Cottam Solar Project

Environmental Statement

Figure 8.16.4: Landscape and Ecology Mitigation and Enhancement Plan – Cottam 1 South (Sheet 1) Revision A

Document reference: EX1/C6.4.8.16.4_A

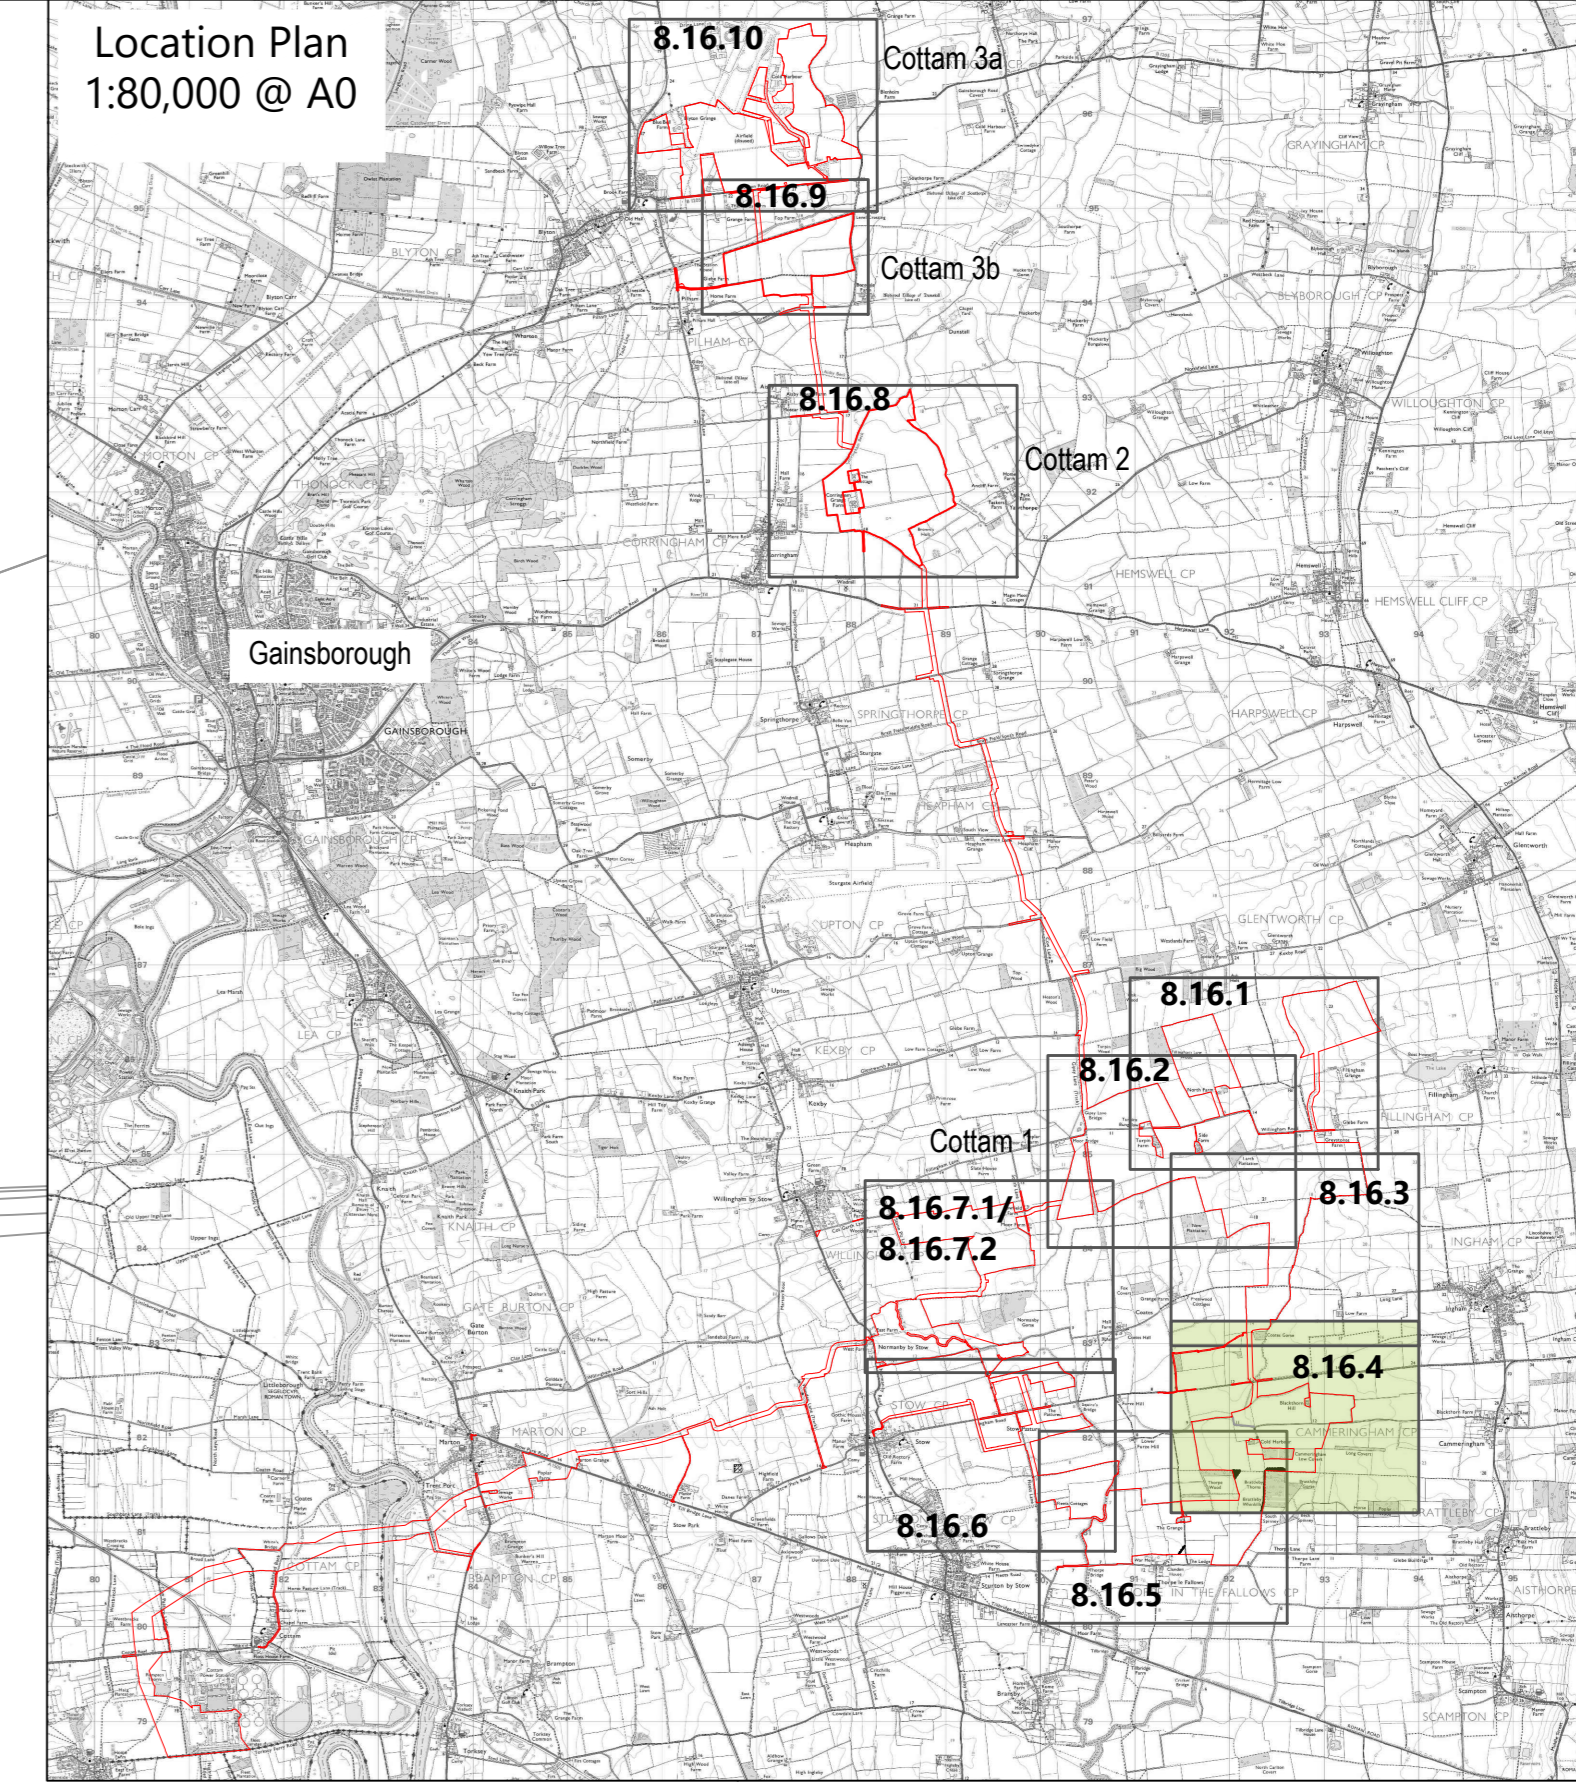
Figure Reference	Page	Description of Changes	Reason for Revision
Figure 8.16.4	3	Change to spelling of 'enhancement'. Offset calculations from drains.	For clarity and to correct a typo.
